**Final
PCB Removal Action Work Plan,
South Pacific Division Laboratory, 25 Liberty Ship Way, Sausalito, California**

September 2005

Response to Comments

Comment response table for; Draft Final Removal Action Work Plan, South Pacific Division Laboratory, Sausalito, California, dated April 2005, by the US Army Corps of Engineers

Figure 1. Location of the SPD Laboratory, Sausalito, California.

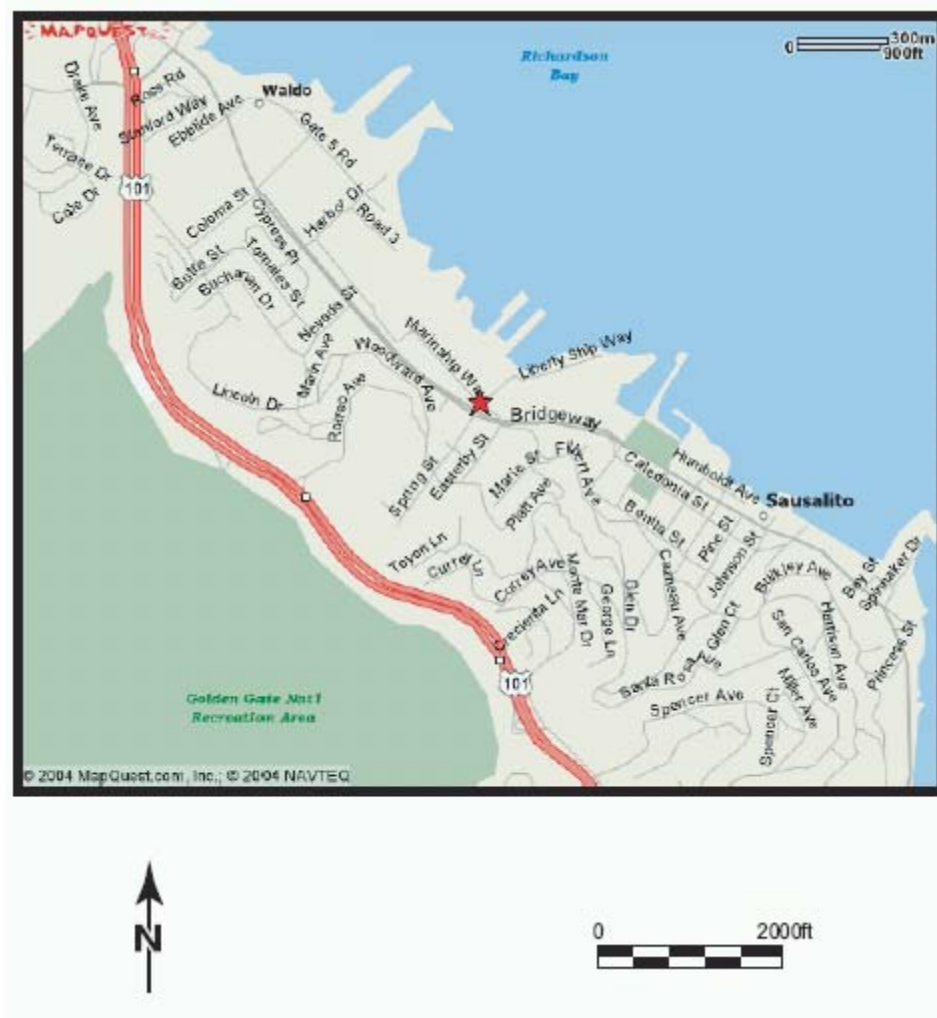
| Number | Comment | Response |
|----------------------|---|---|
| 9. Section 2.1, pg 7 | Determine if there is a drinking water well within one mile from the site under investigation. Provide the distance to the closest water body. | The RAWP will be changed to indicate that there are no drinking water wells within one mile of the site and to indicate that Richardson Bay is adjacent to the site. |

Figure 2
Proposed Excavation Area
Action Memorandum
August 2005

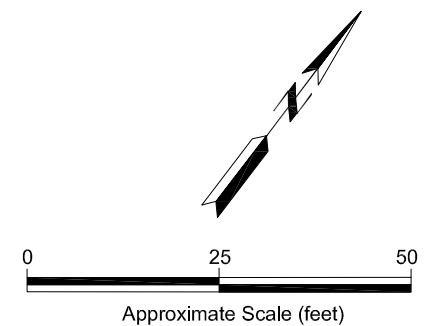
| Number | Comment | Response |
|--------------------------|--|--|
| 14. Section 6.2.1, pg 15 | Provide the basis for the pre-determined dimensions of the proposed excavation areas. The volume and extent of the excavated areas should be based on meeting the cleanup criteria. | The extent of the excavation shown in the RAWP makes use of all existing chemical data to identify the soil most likely to contain concentrations that exceed the clean-up criteria. |
